# UNITED STATES PATENT AND TRADEMARK OFFICE

| APPLICATION NO.   | FILING DATE | FIRST NAMED INVENTOR | ATTORNEY DOCKET NO.       | CONFIRMATION NO.       |
|---|-------------|----------------------|---------------------------|------------------------|
| 10/528,207  | 03/17/2005  | Harald Hagen         | 11138-018                 | 4540                   |

| <b>Office Action Summary</b> | <b>Application No.</b><br>10/528,207 | <b>Applicant(s)</b><br>HAGEN, HARALD |  |

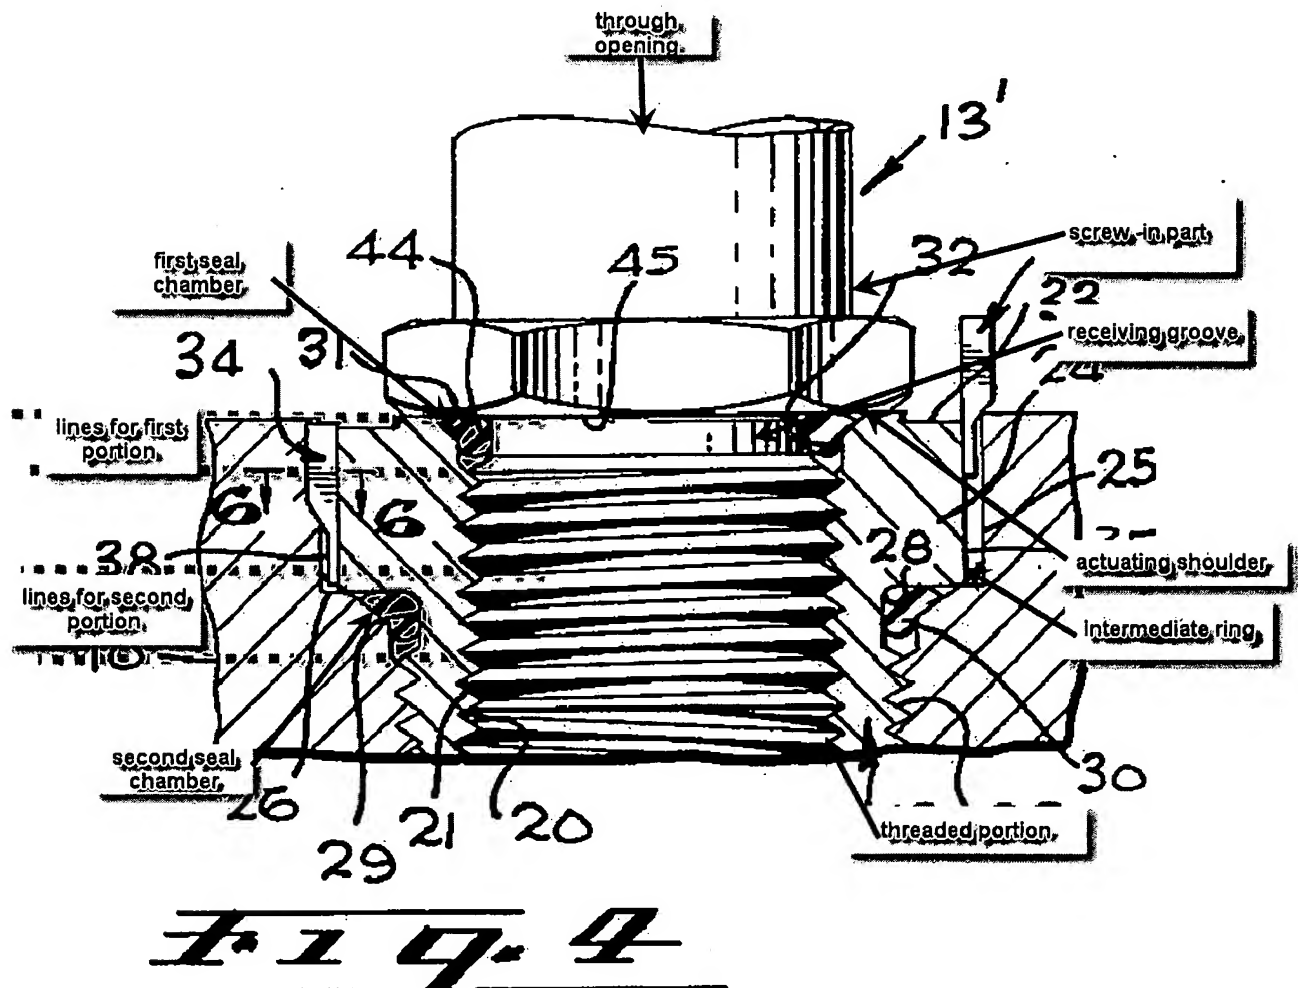
7. In regard to claim 1, Neuschotz, in Figure 4 below, discloses an adapter assembly comprising:

a screw-in part having a through-opening, an externally threaded portion having an outer thread diameter, an actuating shoulder having an outer shoulder diameter being larger than the thread diameter (as can be observed in Figure 4, below, the outer diameter of the actuating shoulder is diametrically further from the central axis than any of the threads shown), and a receiving groove formed in the transition between the actuating shoulder and the externally threaded portion and a first sealing ring being disposed in the receiving groove

the intermediate ring being adapted to fit onto the externally threaded portion (as observed in Figure 4 below, the intermediate ring is on the threaded portion of the screw-in part) and having first and second axially opposite annular planar portions (lines added to marked Figure 4's below to emphasize the portions),

the first planar annular portion having a first sealing ring seat on a first side facing the actuating shoulder, the first sealing ring seat (part 31) and the receiving groove and the actuating shoulder forming a first sealing chamber for the first sealing ring, and

the second planar annular portion having a planar second sealing ring seat on a side facing away from the actuating shoulder for a second sealing ring such that, when the screw-in part is screwed into the threaded bore of the base part, a second sealing chamber for the second sealing ring is formed between the planar second sealing ring seat, the surrounding surface adjacent the threaded bore, and the externally threaded portion of the screw in part.

(marked cut-out Neuschotz Figure 4)

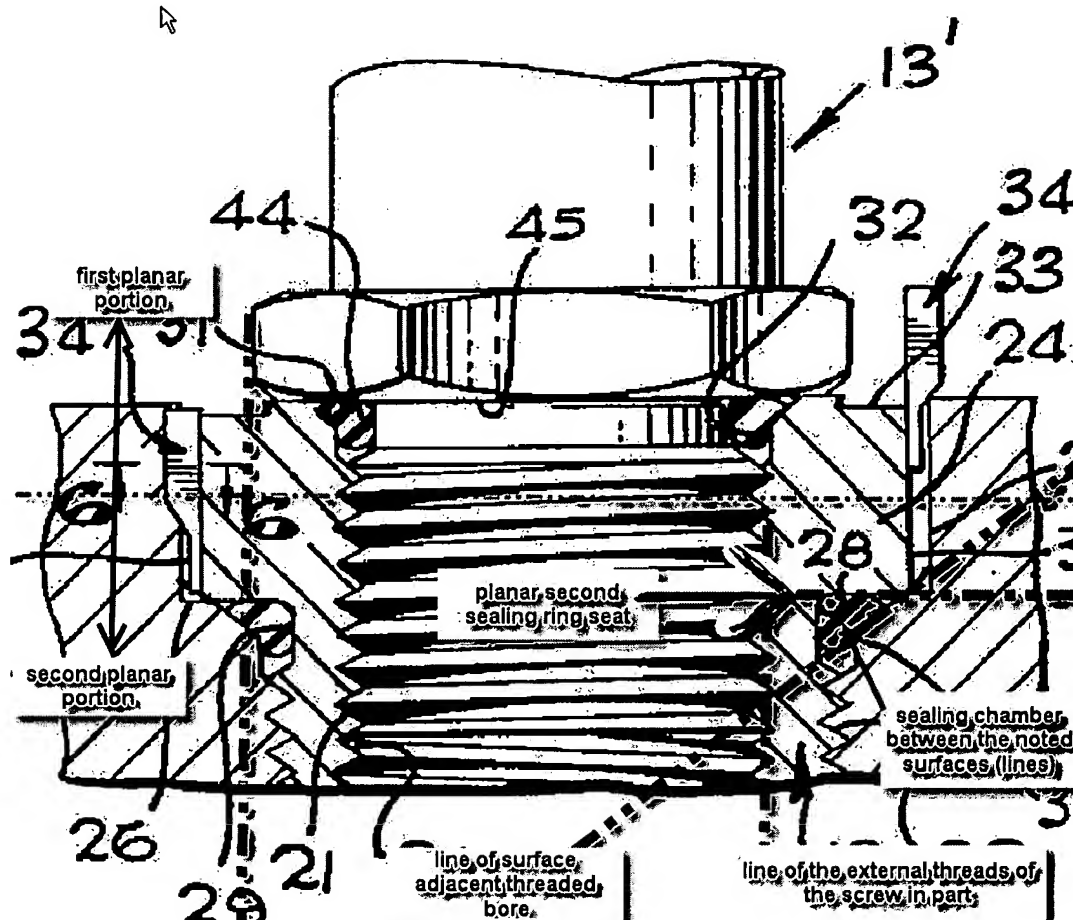
8. In regard to claim 2, Neuschotz further discloses that the first and second sealing ring seats and the associated first and second sealing rings are formed such that, in a mounted state, the first and second sealing rings (as observed in marked cut-out of Figure 4, above) are compressed, the second sealing ring compressed axially without substantial radial deformation against the externally threaded portion (as can be observed in marked cut-out of Figure 4, the second seal ring does not contact the threads).

9. In regard to claim 3, Neuschotz further discloses that the first and the second annular portions are separated by an internal radial web (as observed in marked cut-out of Figure 4 above), which divides the first and second seats from one another.

10. In regard to claim 4, Neuschotz further discloses that the intermediate ring sealing ring seats formed by a radial step surface and an approximately conically widening delimiting surface adjacent to it on the outside (as observed in marked cut-out of Figure 4 above).

11. In regard to claim 6, Neuschotz further discloses that the first annular portion is designed to be smaller in diameter than the second annular portion (as observed in marked cut-out of Figure 4 above).

(marked Neuschotz Figure 4)

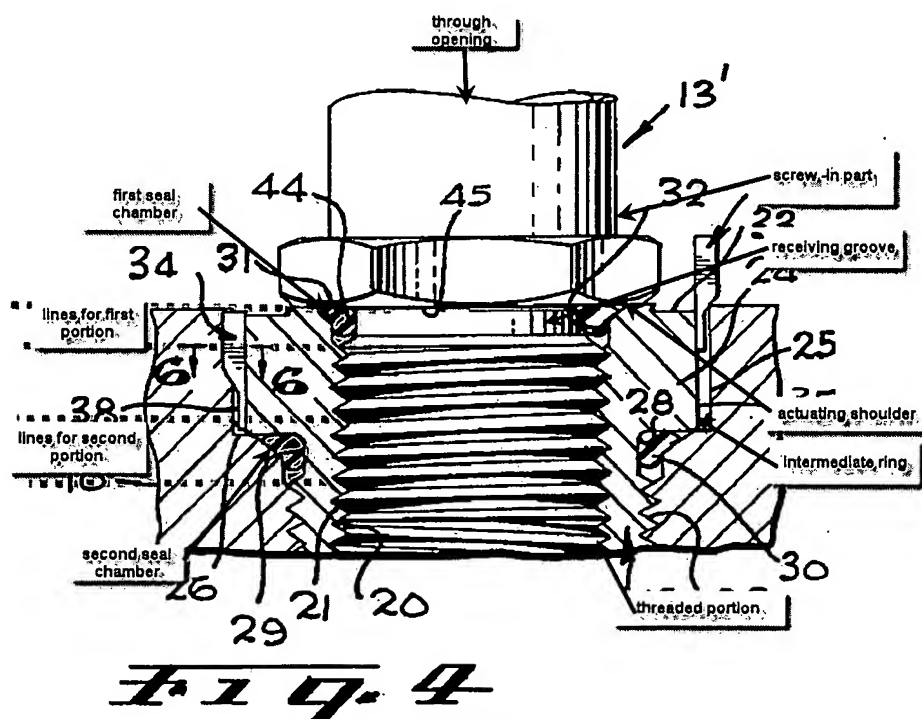
18. In regards to the Applicant's arguments regarding the prior art of Neuschotz, the Applicant's arguments are not persuasive. Applicant argues that Neuschotz fails to disclose "an externally threaded portion having an outer thread diameter configured for screwing into a threaded bore of a base having a surrounding surface adjacent to a mouth of the threaded bore" as recited in lines 4-6 of claim 1. The recited phrase indicates an intended use as indicated by "configured for". The term "configured" is defined to mean: to design, arrange, set up, or shape with a view to specific applications or uses. The phrase "configured for" therefore is interpreted to mean capable of being so configured and as an intended use. Note that it has been held that a recitation with respect to the manner in which a claimed apparatus is intended to be employed

does not differentiate the claimed apparatus from a prior art apparatus satisfying the claimed structural limitations. *Ex parte Masham*, 2 USPQ2d 1647 (1987). Neuschotz discloses the positively claimed structure of an externally threaded portion of a screw-in part as observed in Figure 4, below, and therefore the claim limitation is met. The argument is not persuasive.

(marked cut-out Neuschotz Figure 4)

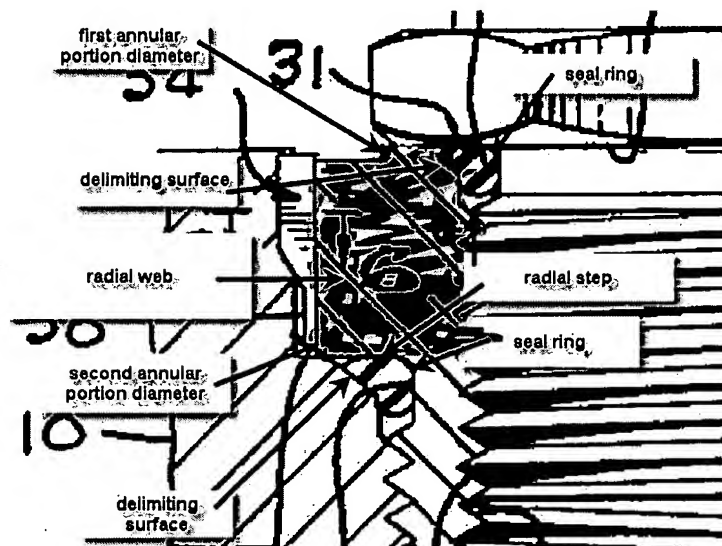
19. Further, the Applicant argues that Neuschotz fails to disclose that “a second sealing chamber the second sealing ring is formed between the planar second sealing ring seat, the surrounding surface adjacent the threaded bore, and the externally threaded portion of the screw in part” as recited in lines 20-23 of claim 1. Neuschotz discloses the claimed structural components, i.e. the planar second sealing ring seat, a surface adjacent the threaded bore, and the externally threaded portion of the screw in part. Further, it is noted that neither term “between” nor the term “adjacent” carry any particular requirements as to closeness of location. “Adjacent”

means: lying near or close. "Between" means: in the position or interval separating. A broad interpretation does not ensure that the noted structural features are the physical boundaries of the second sealing chamber. Neuschotz discloses his second sealing chamber between the noted structural, as shown below in a cut-out of Neuschotz Figure 4. The Applicant's arguments are not persuasive.
